(12) United States Design Patent (10) Patent No.:

(54)	CLOSURE					
(75)	Inventor:	Rodney Malcolm Druitt, Warwickshire (GB)				
(73)	Assignee:	Owens-Illinois Closure Inc., Toledo, OH (US)				
(**)	Term:	14 Years				
(21)	Appl. No.: 29/153,552					
(22)	Filed:	Jan. 11, 2002				
Related U.S. Application Data						
(62)	Division of application No. 29/132,510, filed on Nov. 13, 2000.					
(30)	Foreign Application Priority Data					
May 12, 2000 (AU)						
` /	, ,	Cl 09-07				
(52)	U.S. Cl.					
(58)	Field of Se	earch				
	D9/45	3, 438; 215/235, 250, 257, 258; 220/200,

It is certified that error appears in the above-identified patent and that said Letters Patent is hereby corrected as shown below:

FIG. 7

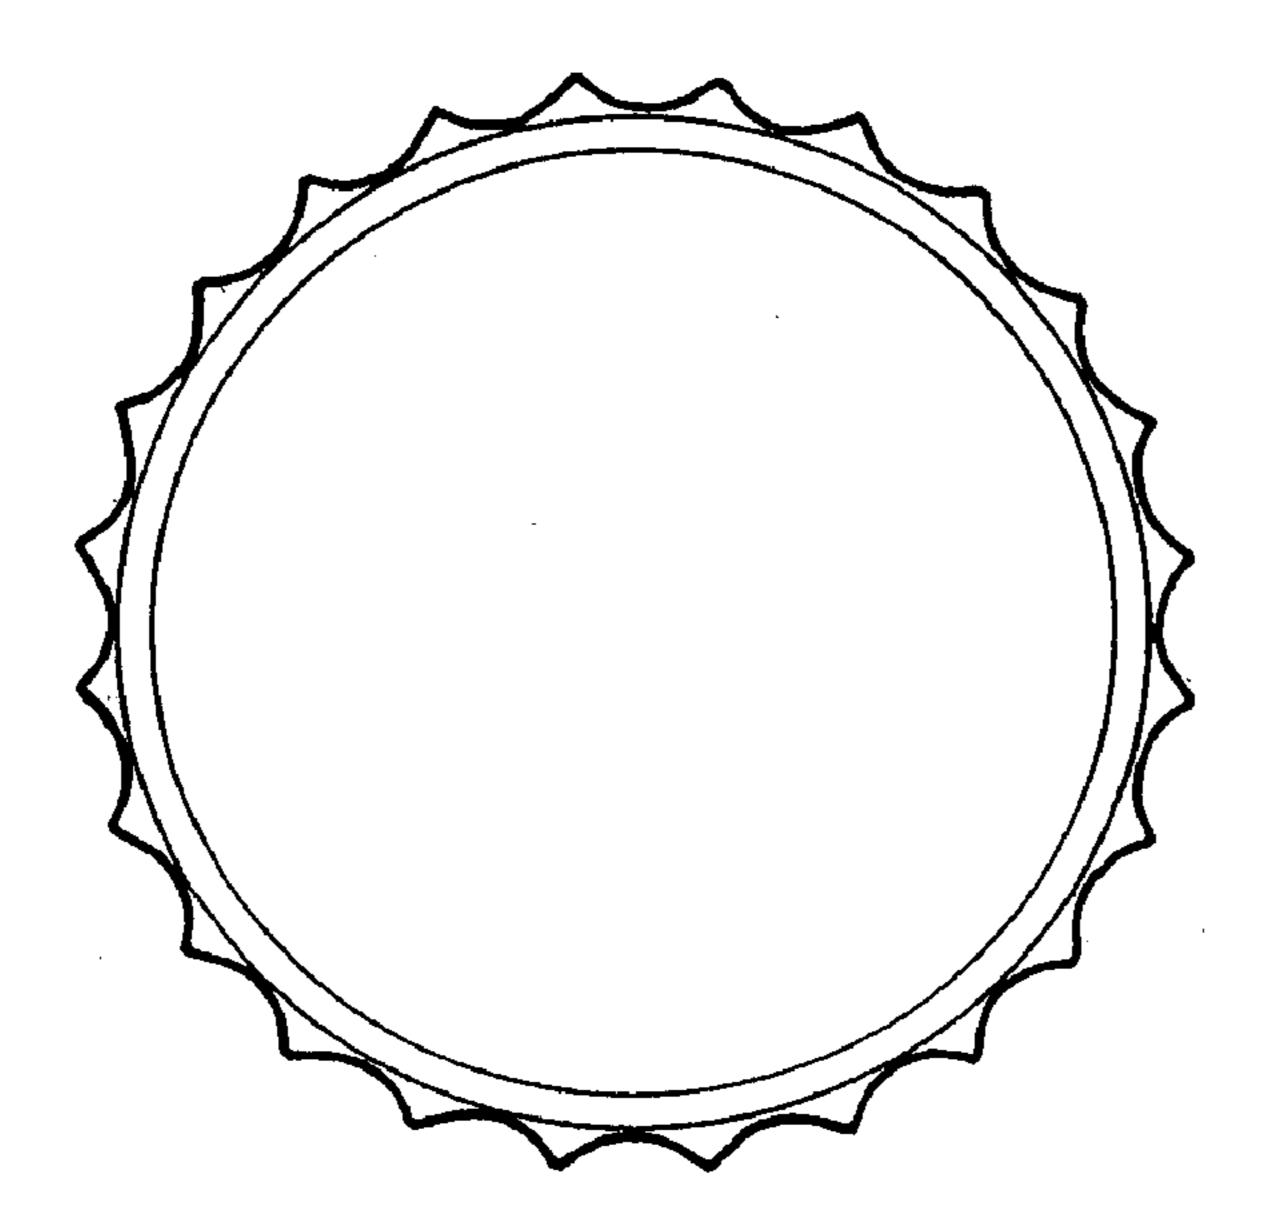
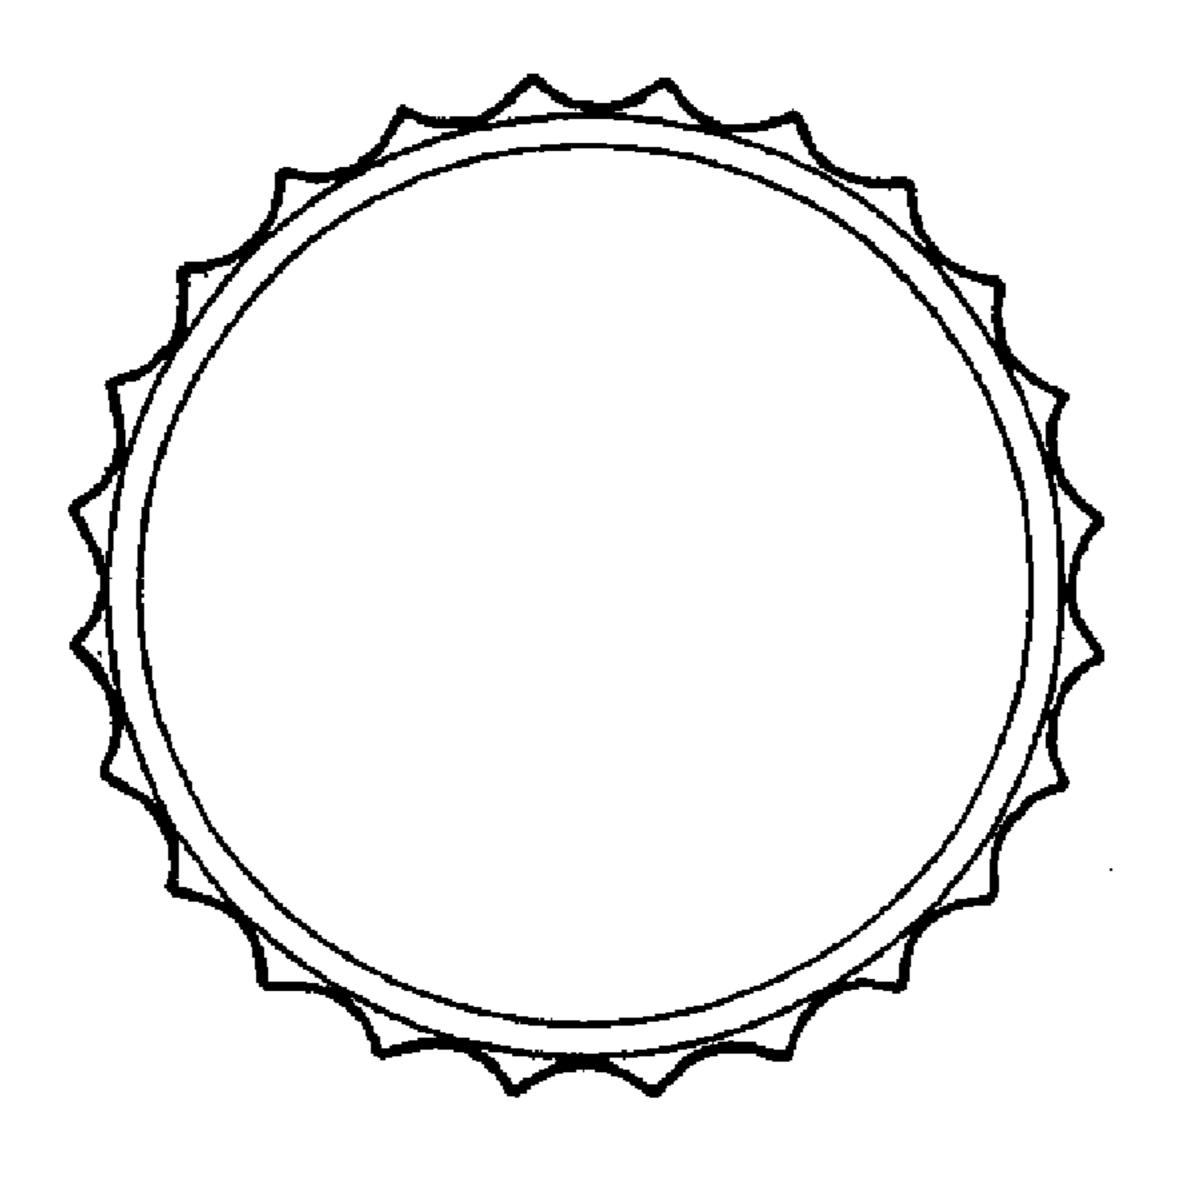
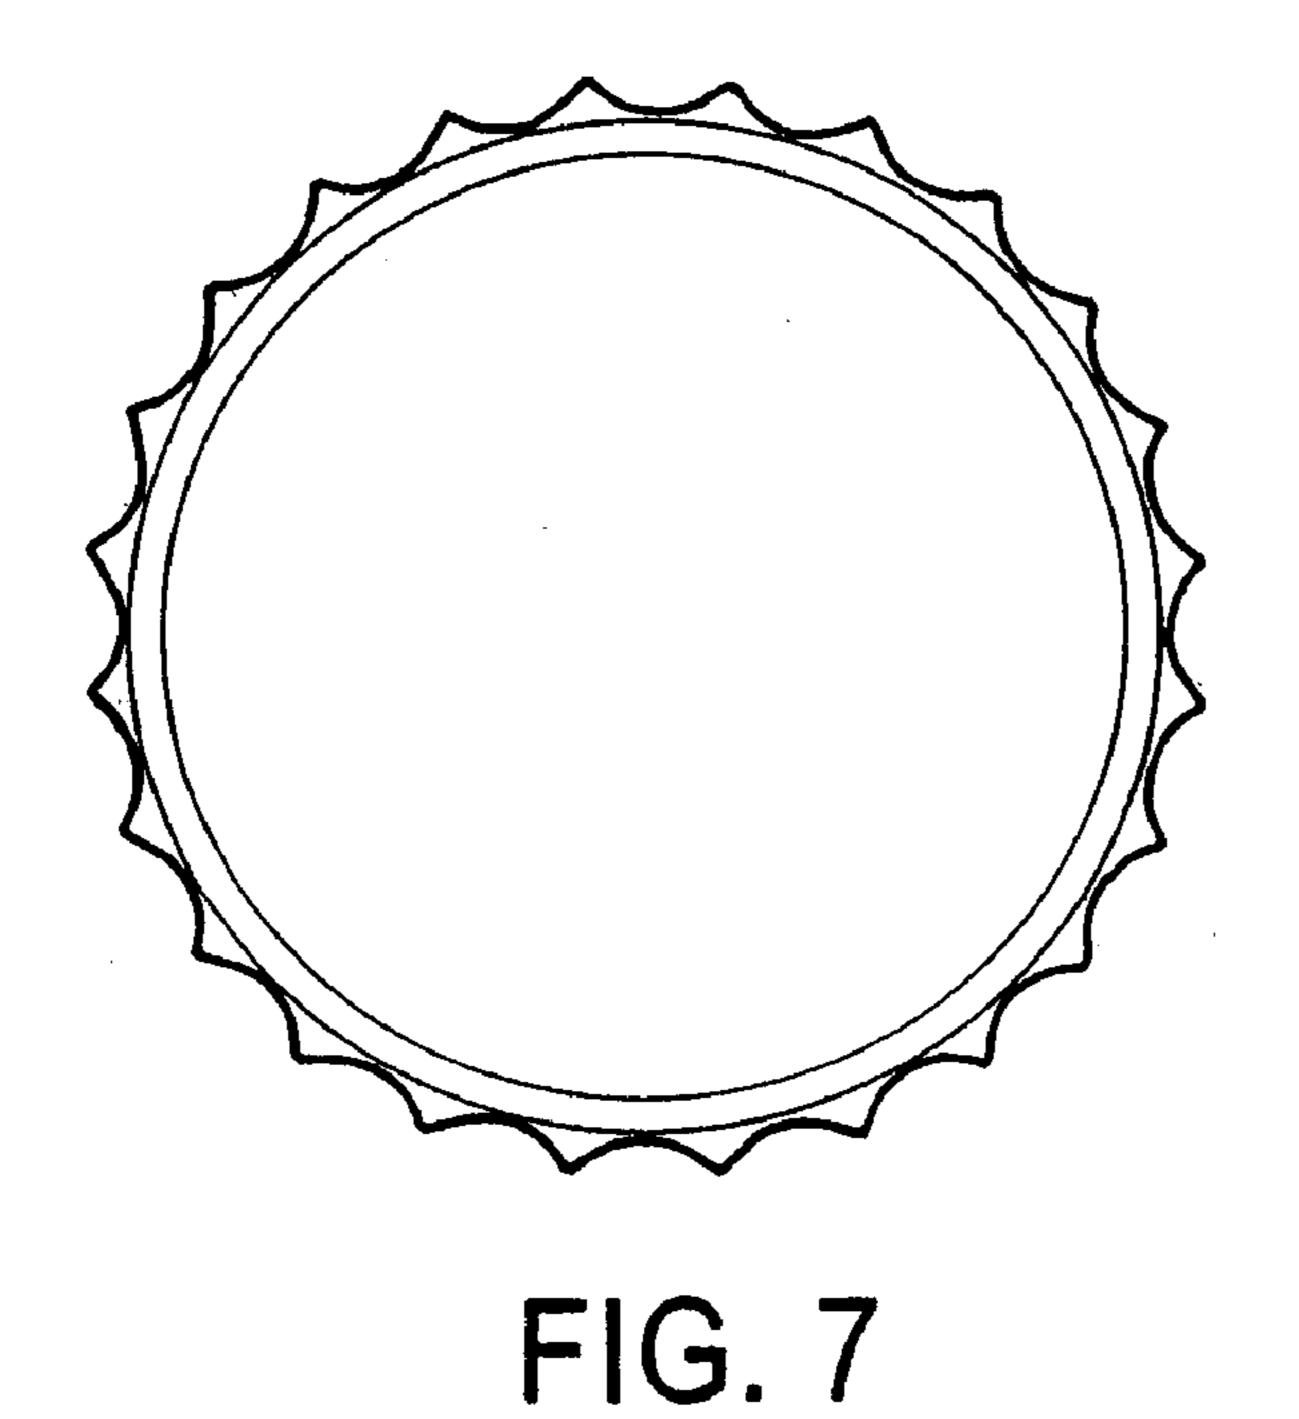
Figures 2, 5, 7 and 10 should be as attached.

Figure 7, should be as below.

Figure 7, should be as below.
